Access Compliance Report

Public Rights-of-Way

Intersection ID: 48373	Main Street: WHEATFIELD_RD	Cross Street: GARDEN_VIEW_DR	Location: NE
ADA ID: CBABB74ED9EC	Ramp Type: PerpDiag	Initial Pass/Fail: Fail	Overall Compliance: No
		Severity Score: 8.75

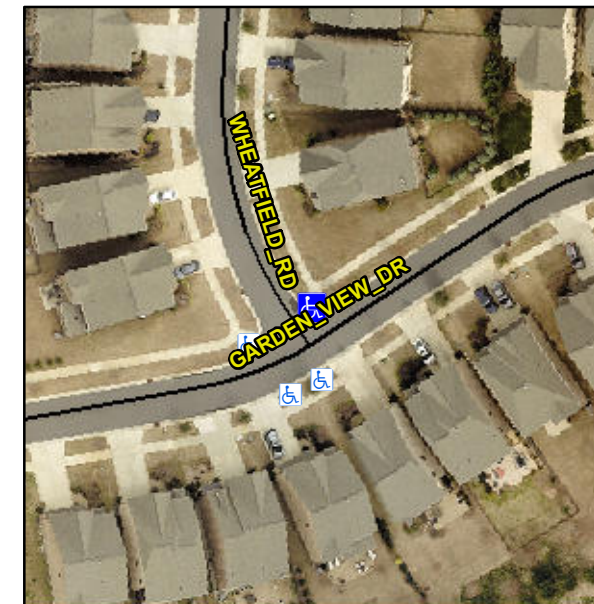
Not Found, R304.5.1

Compliance	Description	Data	Compliance	Description	Data
N/A	Ramp Length (in)	96.0	Yes	Ramp Slope (%)	7.0
No	Ramp Width (in)	47.0	Yes	Ramp XSlope (%)	0.7
N/A	Flare Type LT	N/A	N/A	Flare Type RT	N/A
N/A	Flare Slope LT (%)	N/A	N/A	Flare Slope RT (%)	N/A
N/A	Flare Traversable LT?	N/A	N/A	Flare Traversable RT?	N/A
N/A	Landing Length (in)	N/A	N/A	DWS Provided?	N/A
N/A	Landing Width (in)	N/A	N/A	DWS Contrast?	N/A
N/A	Landing Slope (%)	N/A	N/A	DWS Length (in)	N/A
N/A	Landing X Slope (%)	N/A	N/A	DWS Full Width?	N/A
N/A	Landing Curb? (Y/N)	N/A	N/A	DWS Offset (in)	N/A
N/A	Shared Landing?	N/A			
N/A	Gutter Ponding?	N/A	N/A	Gutter Slope (%)	N/A
N/A	Gutter Lip Ht (in)	N/A	N/A	Gutter X Slope (%)	N/A
N/A	Painted X Walk1?	No	N/A	Painted X Walk2?	No
	X Walk 1 Direction	To SW		X Walk 2 Direction	To SE
N/A	X Walk 1 Width (in)	N/A	N/A	X Walk 2 Width (in)	N/A
	X Walk 1 Slope (%)	0.3		X Walk 2 Slope (%)	1.0
	X Walk 1 X Slope (%)	0.8		X Walk 2 X Slope (%)	1.6

Remove & Replace Curb Ramp With Two New Directional Ramps or Equivalent.
